RE: Response to IDNR Letter Dated July 14, 2026 (Doc #117567)
Grundy County Sanitary Landfill
IDNR Permit No. 38-SDP-01-75C

SITE PLAN
CAP STABILITY PROJECT
GRUNDY COUNTY SANITARY LANDFILL
GRUNDY CENTER, IOWA

FIGURE: 1		
REVISION	NO.	DATE
DRAWN JGH	PROJECT NO. 6033-26A	DATE 7/23/26

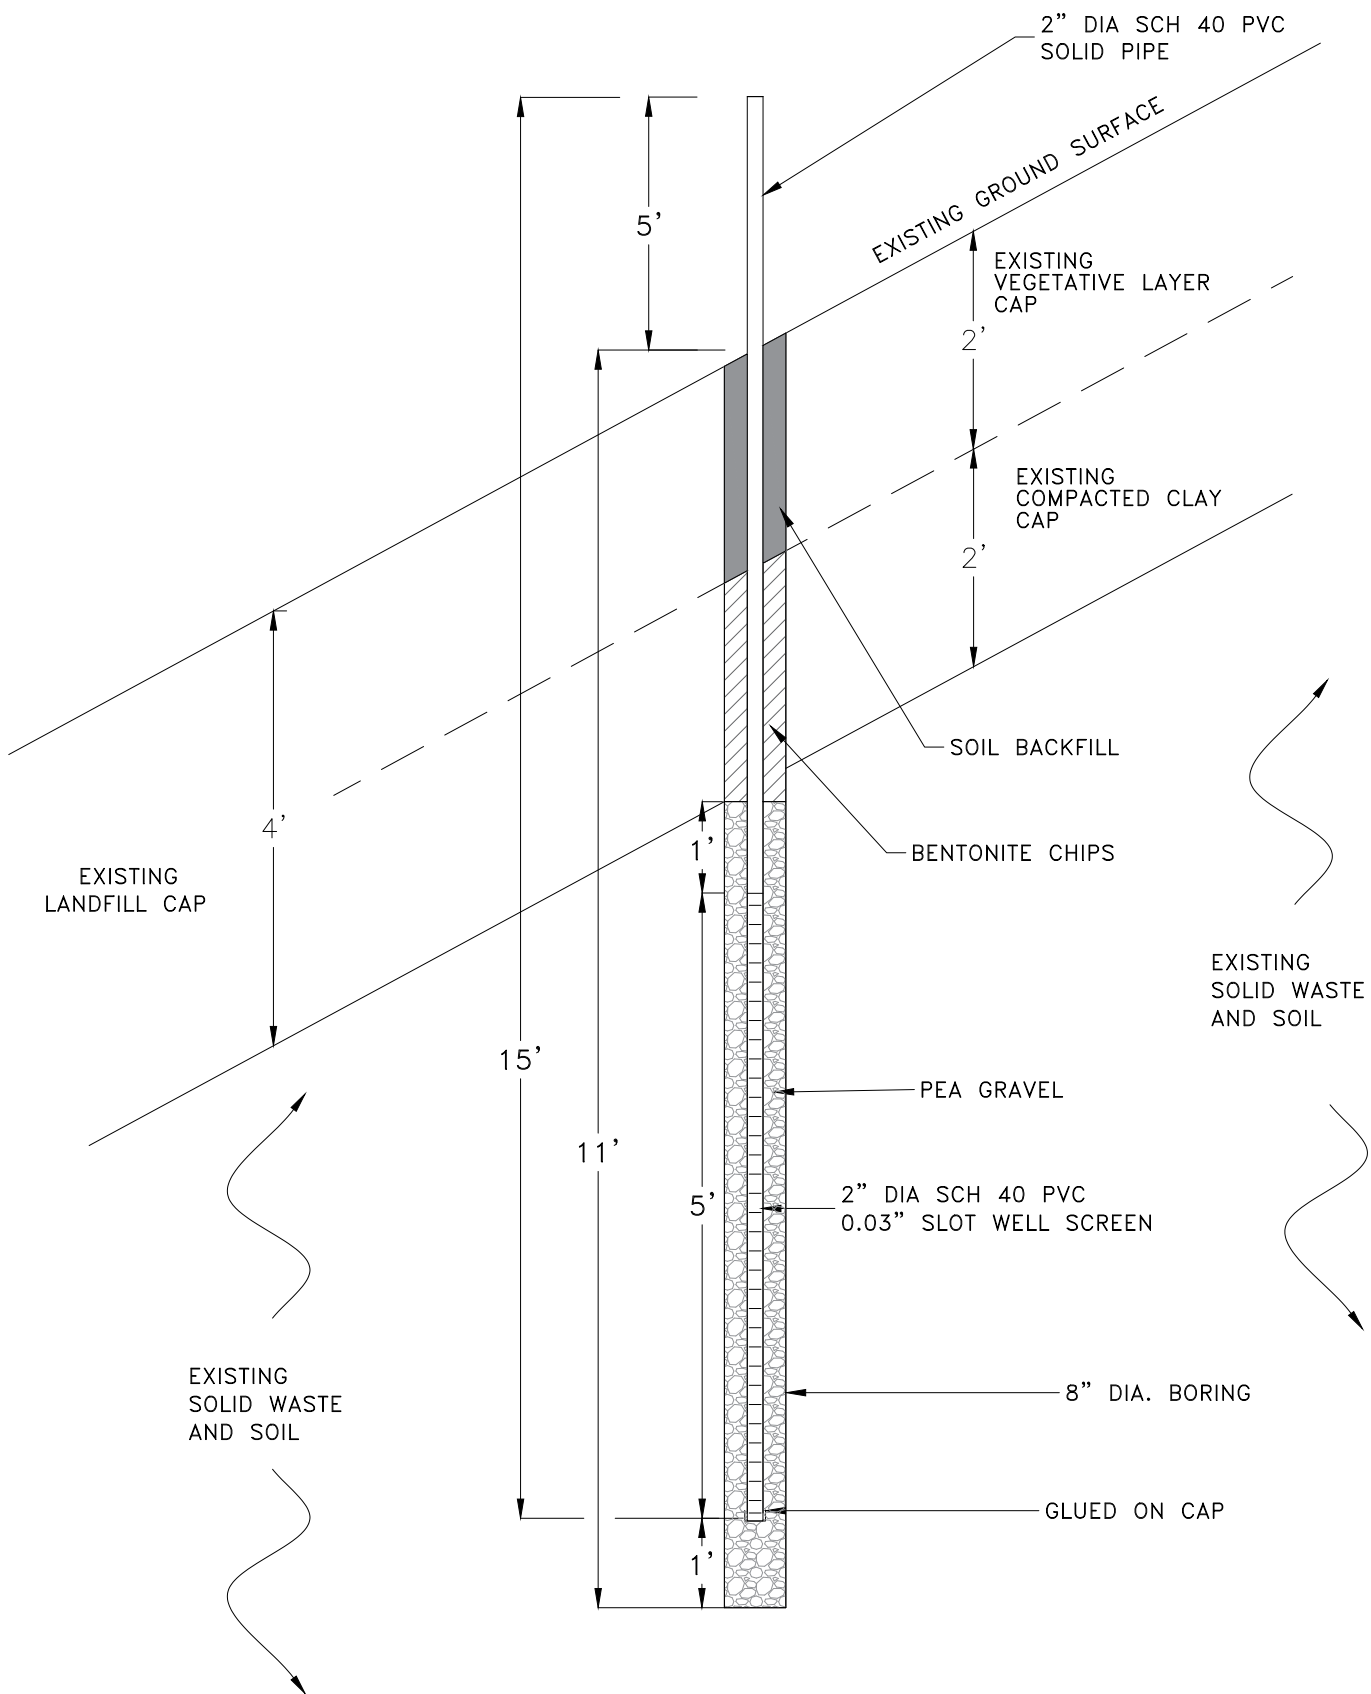
This letter is being submitted in response to the IDNR letter dated July 14, 2026 (Doc #117567) and presents the plan and schedule to address the vegetation bare spots located in isolated areas of the landfill cap (Figure 1). The planned actions are intended to address the last remaining item before the IDNR and the Grundy County Landfill Commission (GCLC) enter negotiation of an Environmental Covenant.

Approximately eighteen (18) gas vents will be drilled at select locations on the cap in the proximity of bare areas and stressed vegetation. The vents will be constructed by drilling an 8.25-inch diameter hole to a depth of approximately 11 feet below grade. The drilled hole will then have 2.0-inch PVC screen and pipe installed as illustrated on the attached detail (Figure 2). The annular space between the PVC and the drilled hole will be backfilled with pea gravel and sealed with bentonite clay chips. The integrity of the landfill cap will be maintained using the bentonite and the vegetative topsoil.

Limestone rock (3-inch clean) will be transported to the landfill and will be placed over the bare soil areas as 6-inch to 8-inch-thick pavements. The bare soil will not be removed but will be smoothed and prepared prior to the addition of the rock pavements. Fabric will not be placed under the rock pavements. The lack of fabric will promote the growth of vegetation within and through the rock pavements as gas venting improves the vegetative health and soil conditions in these areas.
